Subject: Response to Administrative Comments
B50 Temporary Aboveground Waterline
JPA Application No. E0407222-001
Economy Borough, Beaver County, Pennsylvania
CEC Project 317-457

PENNERGY RESOURCES, LLC
B50 TEMPORARY ABOVE-GROUND WATERLINE ECONOMY BOROUGH BEAVER COUNTY, PA

STREAM AND FLOODWAY CROSSING DETAILS

DETAIL 1
PROPOSED TEMPORARY INTAKE
(BIG SEWICKLEY CREEK)

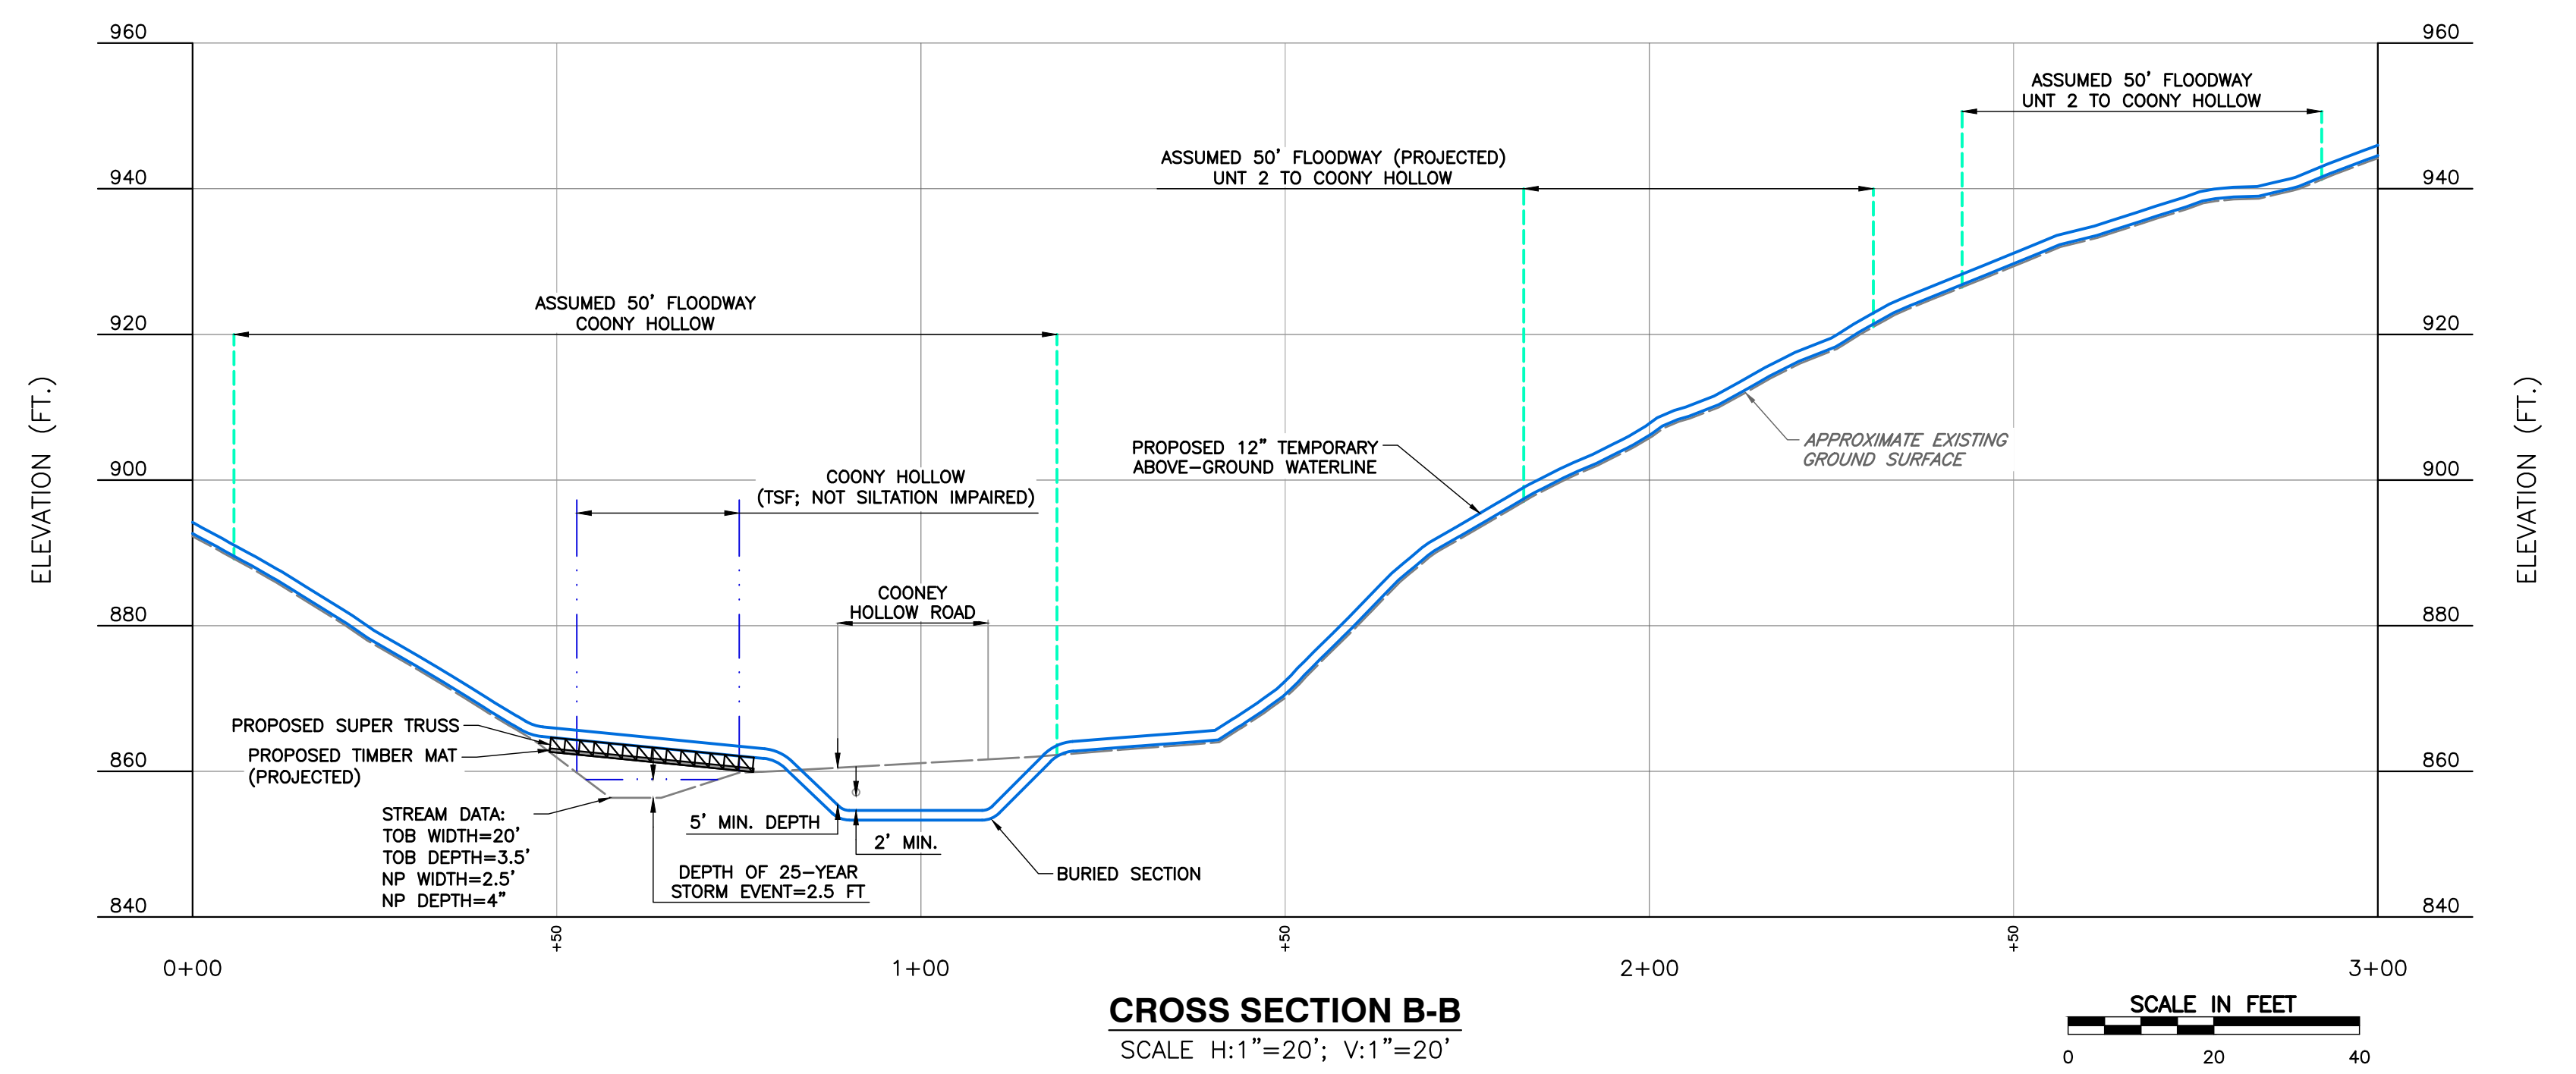
- 3. In response to Comment #3 and Comment #10, the E&S Control Plan was updated to include a construction detail of the proposed Dolphin Floating Suction Strainer, but the plan view (JP01:Detail 1) of the proposed intake was not updated to depict the intake placement within Big Sewickley Creek. As mentioned all plans need to depict the final construction plan. Please update Drawing JP01 Detail 1, or provide an additional plan view drawing, to show all (7) proposed strainers and associated piping within Big Sewickley Creek. 105.13 (e)**

3. In response to Comment #3 and Comment #10, the E&S Control Plan was updated to include a construction detail of the proposed Dolphin Floating Suction Strainer, but the plan view (JP01:Detail 1) of the proposed intake was not updated to depict the intake placement within Big Sewickley Creek. As mentioned all plans need to depict the final construction plan. Please update Drawing JP01 Detail 1, or provide an additional plan view drawing, to show all (7) proposed strainers and associated piping within Big Sewickley Creek. 105.13 (e)

RESPONSE: Drawing JP01 has been revised as requested and is included in Attachment C.
